Planning and Development (Plan Variation No 345) Approval 2019

Notifiable instrument NI2019-164

Variation to the Territory Plan No 345

Mawson Group Centre:
Zone changes and amendments to the
Mawson precinct map and code

Figure 3: Areas subject to rezoning

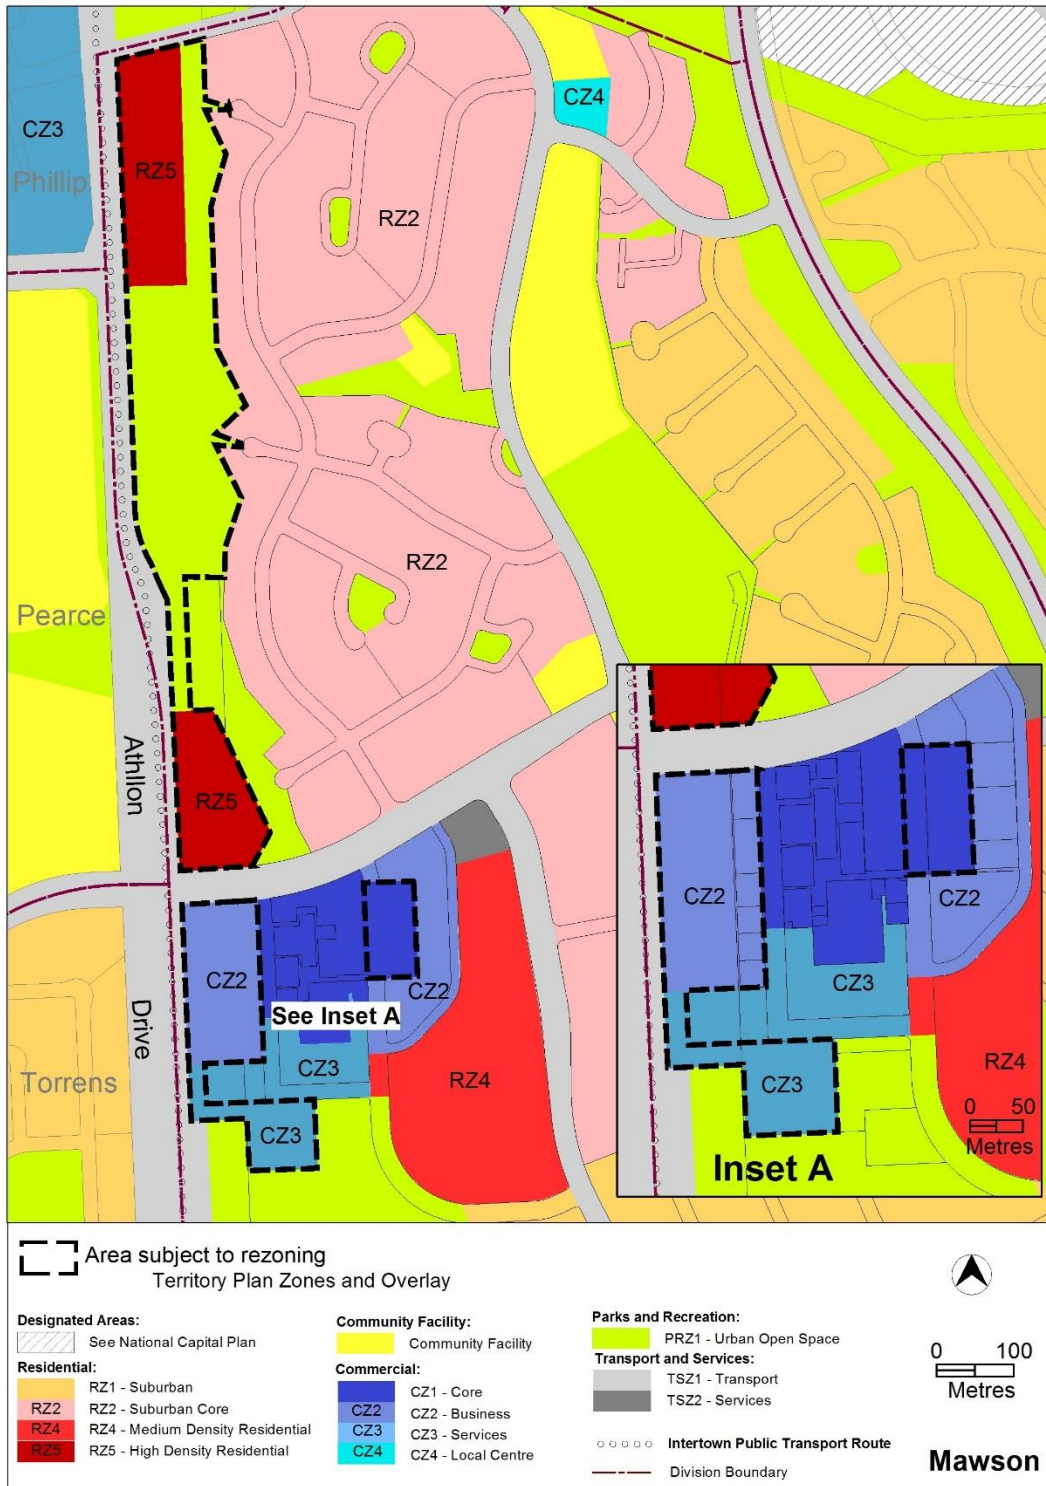
The Territory Plan map is varied as indicated in figure 3:

Mawson Precinct Map

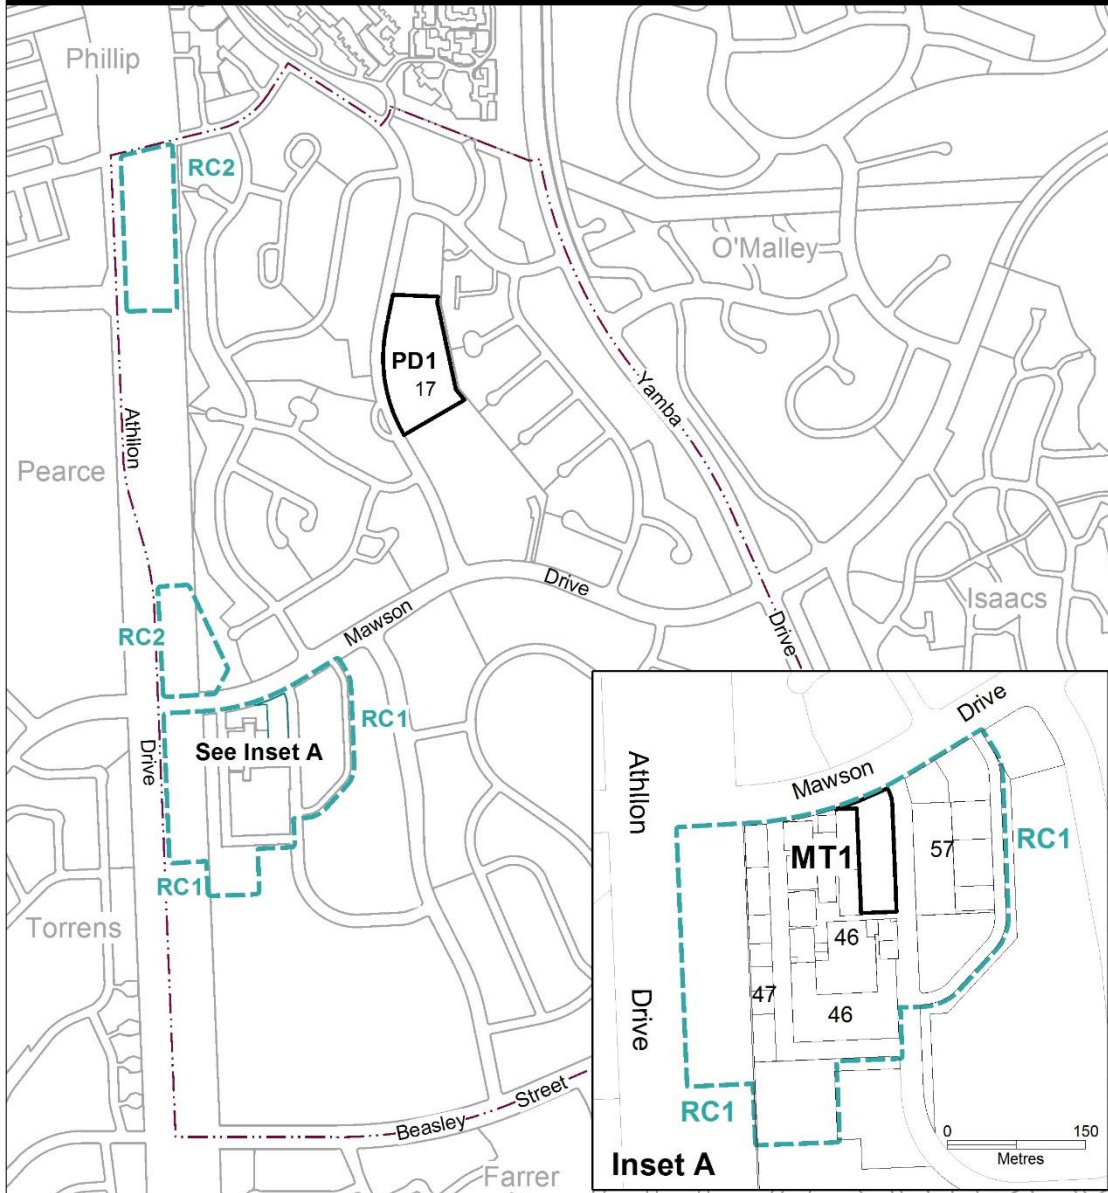
Substitute all of the following with the nominated attachments

Mawson precinct map – Attachment A
